PERMIT

SEWAGE DISPOSAL SYSTEM

Re: Commercial Catering Kitchen
11310 Barley Field Way
PN #B00119208

Re: Building Permit Application
B00119208 - Interior Alteration
to install commercial cooking
equipment @
11310 Barley Field Way

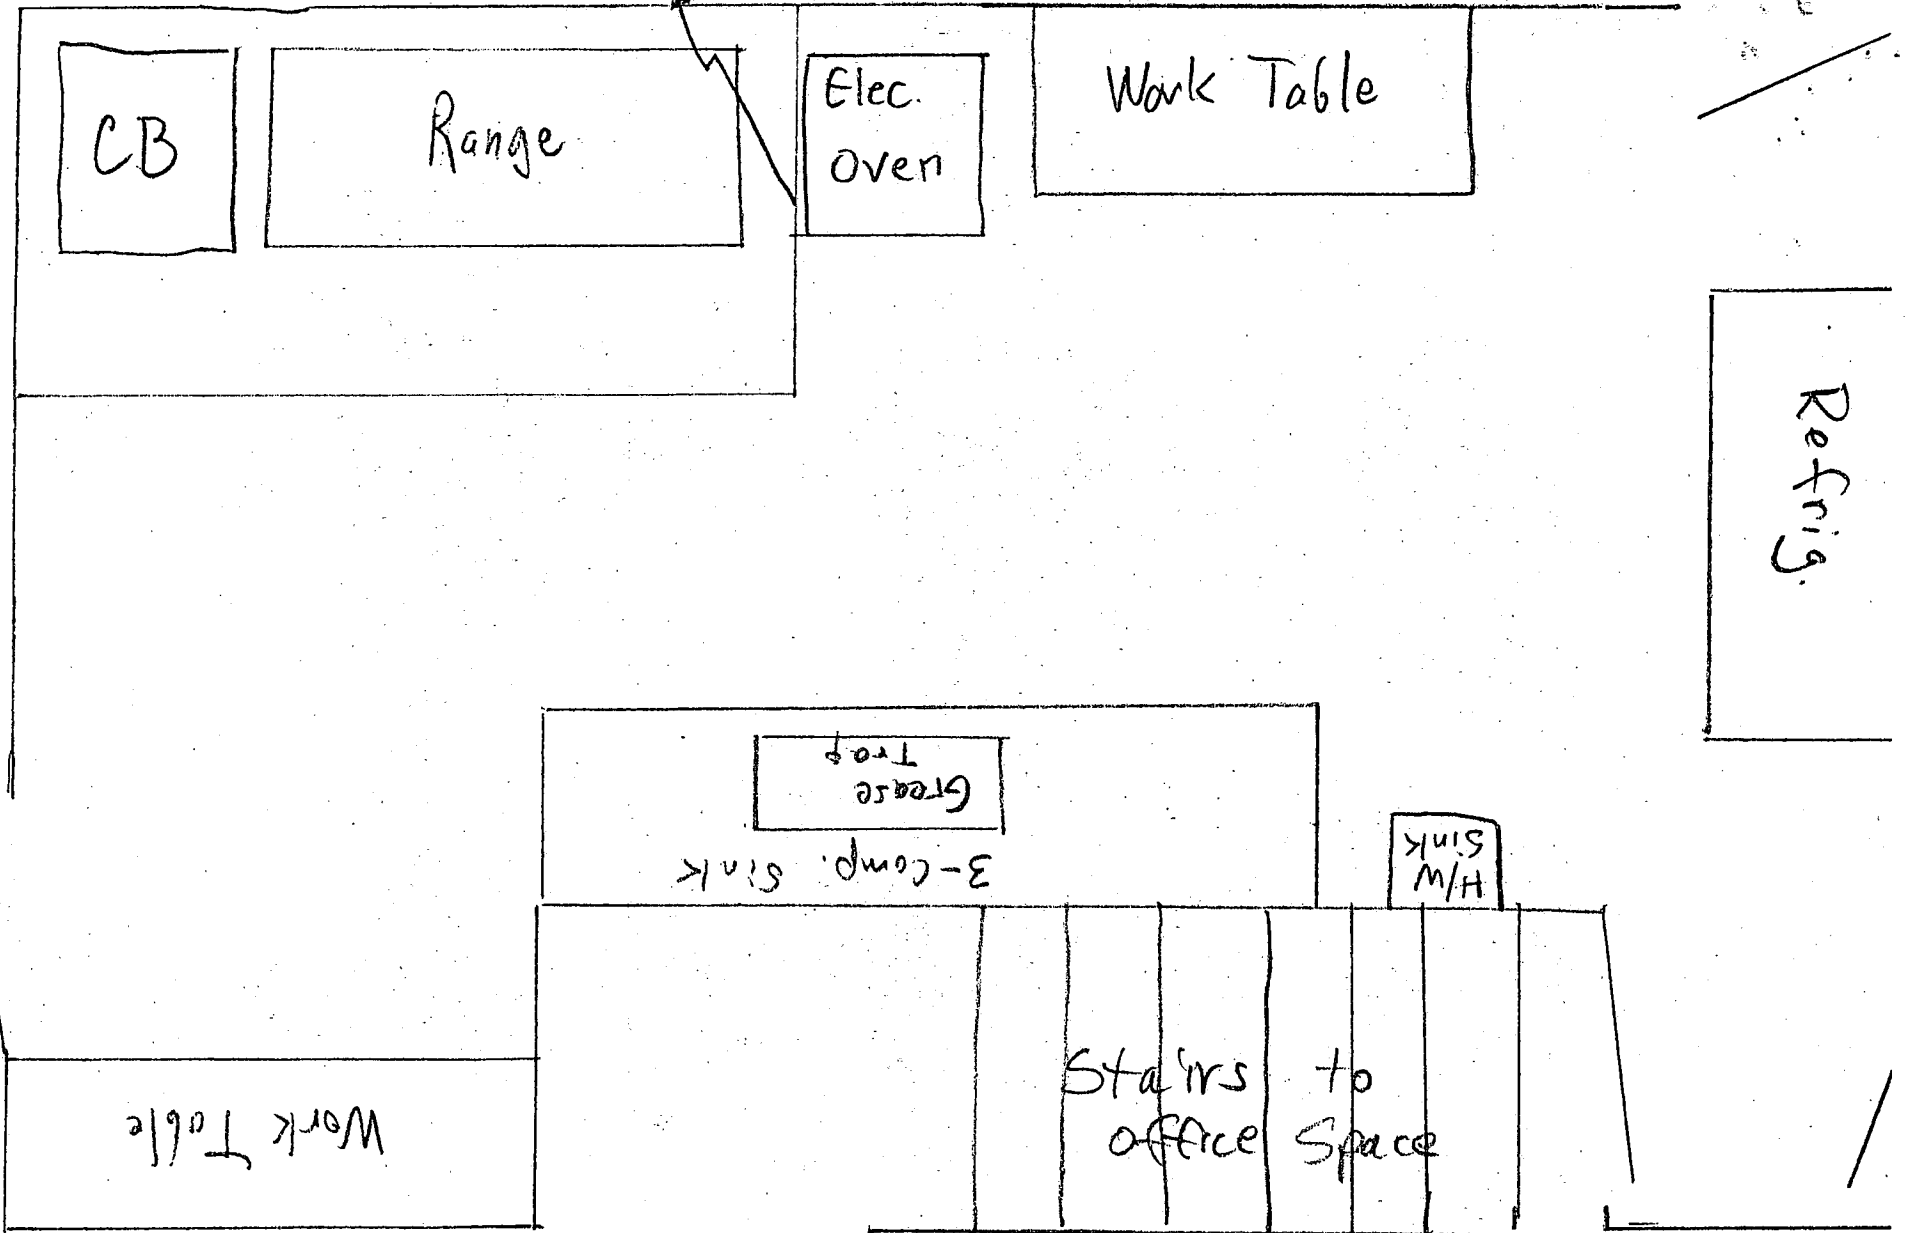
5. EXHAUST SYSTEM Hood ventilation systems in foodservice facilities must comply to COMAR 10.15.03.08. and the Maryland Ventilation Criteria to help insure that ventilation systems in food establishments effectively and safely remove the excessive grease vapors, smoke, heat, steam, fumes, and obnoxious odors produced from activities associated with the processing so as to promote a sanitary and well ventilated environment.
 - A) The specification states a UL Listing. Is that a UL 710 listing?
 - B) The proposal from Guardian describes the exit route of the exhaust duct but does not mention any of the required cleanouts described in N.F.P.A. 96. Please explain.
 - C) Will the Wittco electric oven be used to cook fatty foods or be set at high cooking temperatures? If so, this oven may be required to be under the hood. Please explain the oven's use.

7. THREE BASE SINK The 3 compartment sinks must be of adequate length, width and depth to accommodate the largest piece of equipment or utensil necessary for the operation of your facility. Each sink must be individually and indirectly drained and provided with an air gap. The floor sink must capture the discharge from the three filled sinks (no splash or overflow). Provide sanitizer and appropriate test kit. After discussing your 3 compartment sink drawing with Inspections, Licensing and Permits' plan reviewer and field inspector, our requirement continues to be that the drain lines from all three sinks pass through the grease interceptor. Confirm the correction.

SITE INSPECTION SHEET

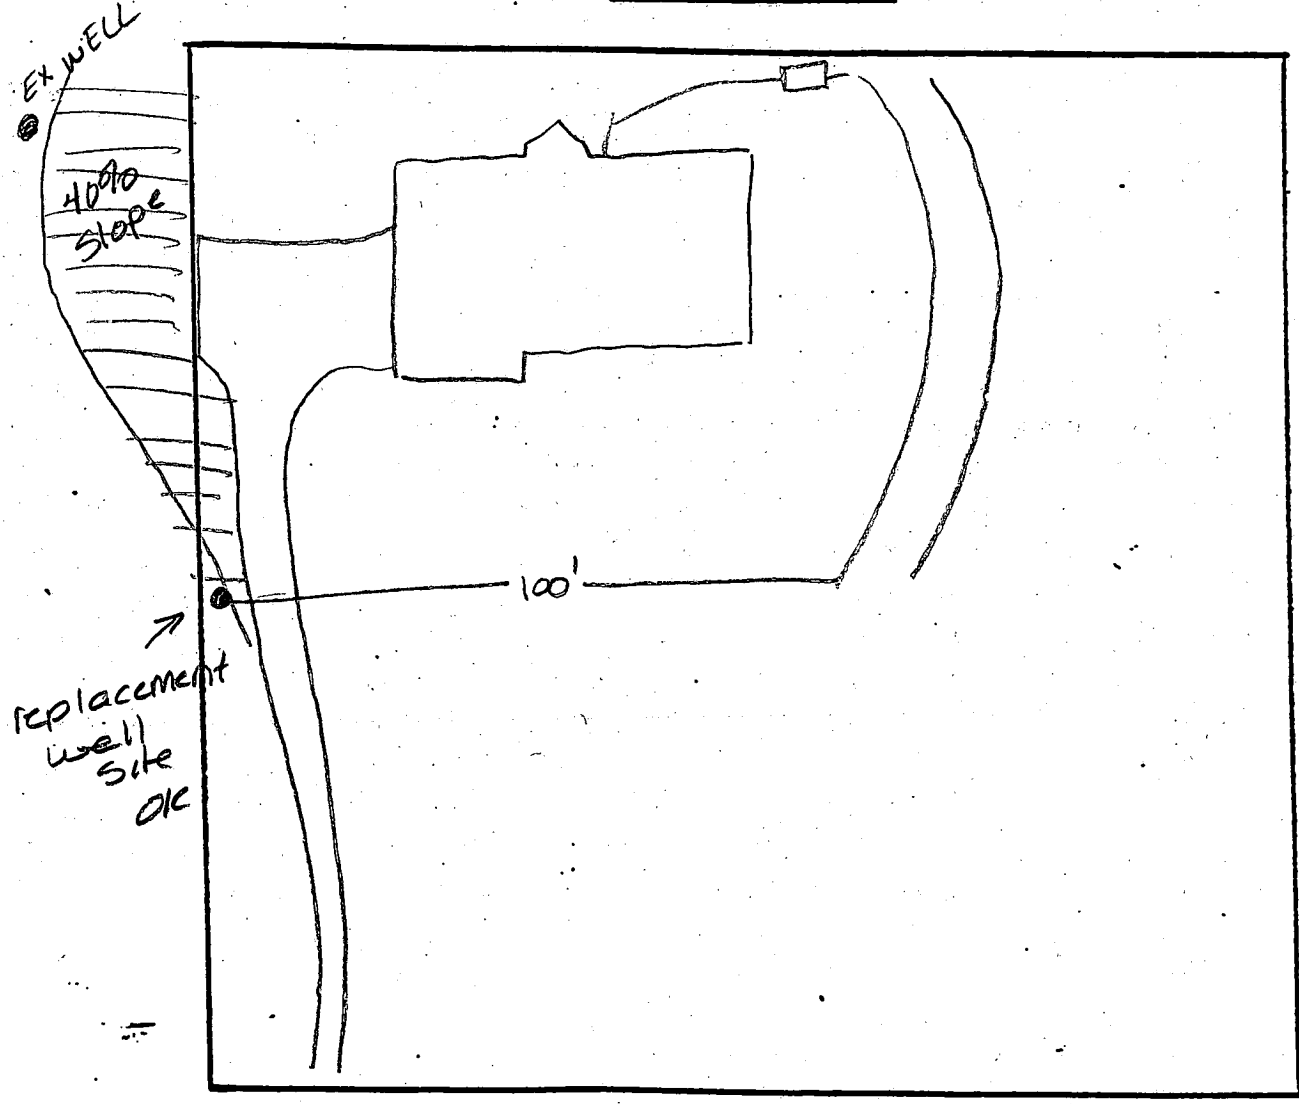
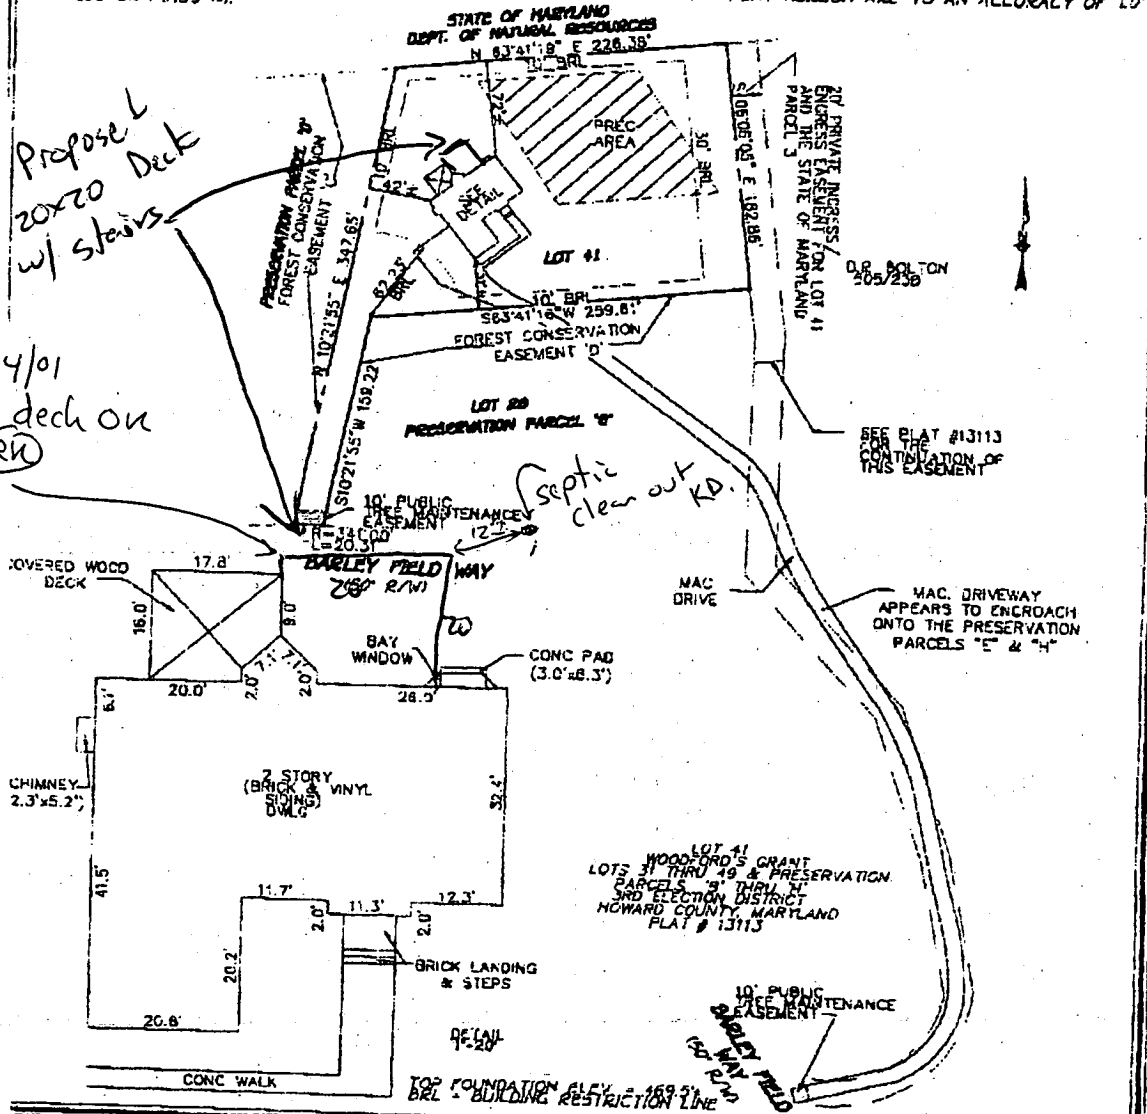
PROPOSAL: Well has possibly gone dry - plumber replacing well line - this may or may not fix problem - want site in case it does not

COMMENTS: Located end of trenches - owner reports he owns 30' to left of driveway - so replacement well site approved as shown
Repair septic area available below existing system - per holes located
